Different technical modifications and updatings on amber 66 – 83

Here below you will find the most important modifications carried out on above-mentioned machines. We ask you to carefully read all the information, necessary for your future orders. We add the updated index with all its revisions, so that you may easily verify which tables are missing in your files and ask for the relative copies.

ref. table 0305-10 R04

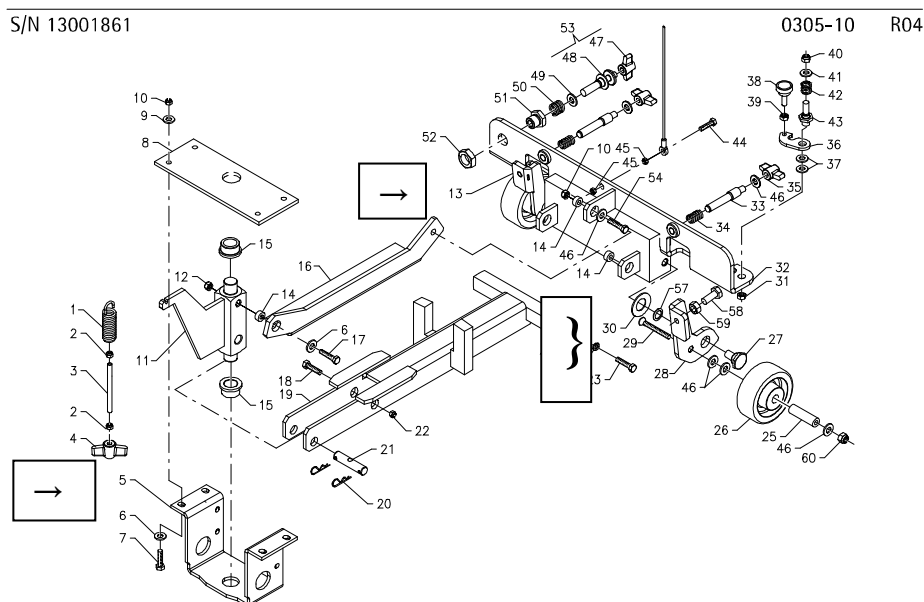
We have had some problems concerning the adjustment, because it was positioned at the limit of the screw, furthermore lifting the squeegee, the supports were not sufficiently blocked and fell down. New supports (pos. 13 and 28) have been assembled that permit a greater adjustment and that have a mechanical limit stop that prevents the wheels to fall down onto the floor. We have modified also the wheel support pin (pos. 27) to improve the fixing to the squeegee support.

The new supports are interchangeable with the previous ones adding the bolts as per revised table.

→ Starting from serial number: 14002021 dated 26/05/14 – table 0305-10 R05

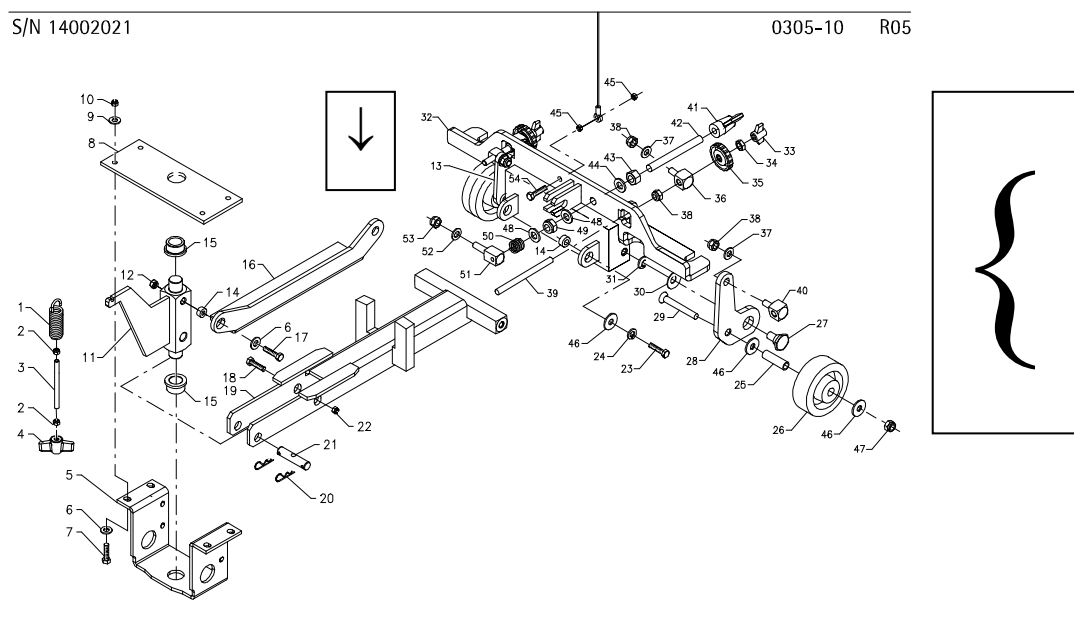
The complete squeegee coupling will be replaced with a new one, because the adjustment with this new system is much more solid also in presence of heavy impacts. Consequently the adjustment system has been modified and therefore a new coupling and new wheel supports are needed. The adjustment will not be anymore by simple leaning onto the support but the new system will be equipped with a threaded tie rod and an adjuster. The new system may be applied integrally also on already produced machines.

Ref. table 0307-10 R00 – pos. 2

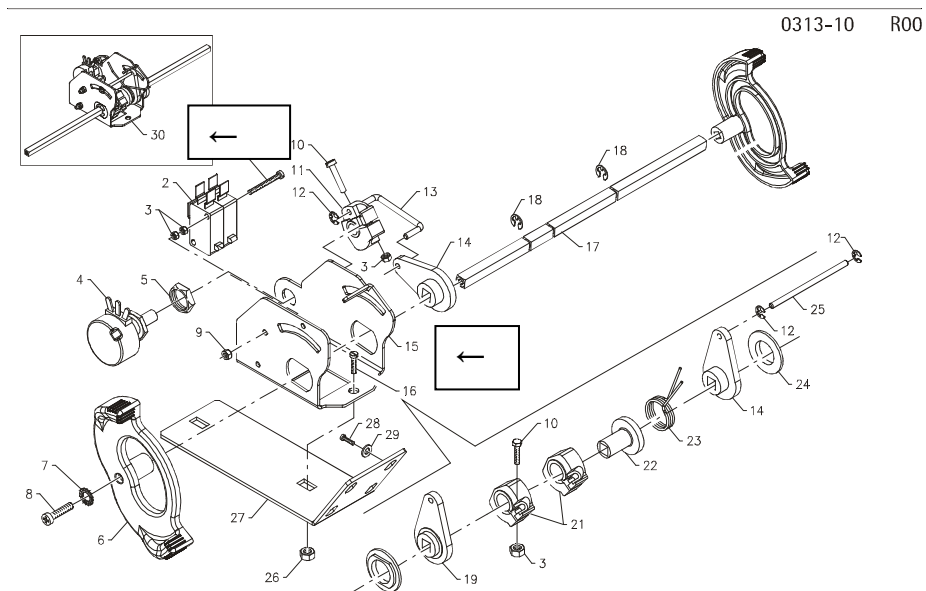
In case you should have slipping problems, you can ask for an anti-skid wheel with double mixing. Its part number is 46524060.
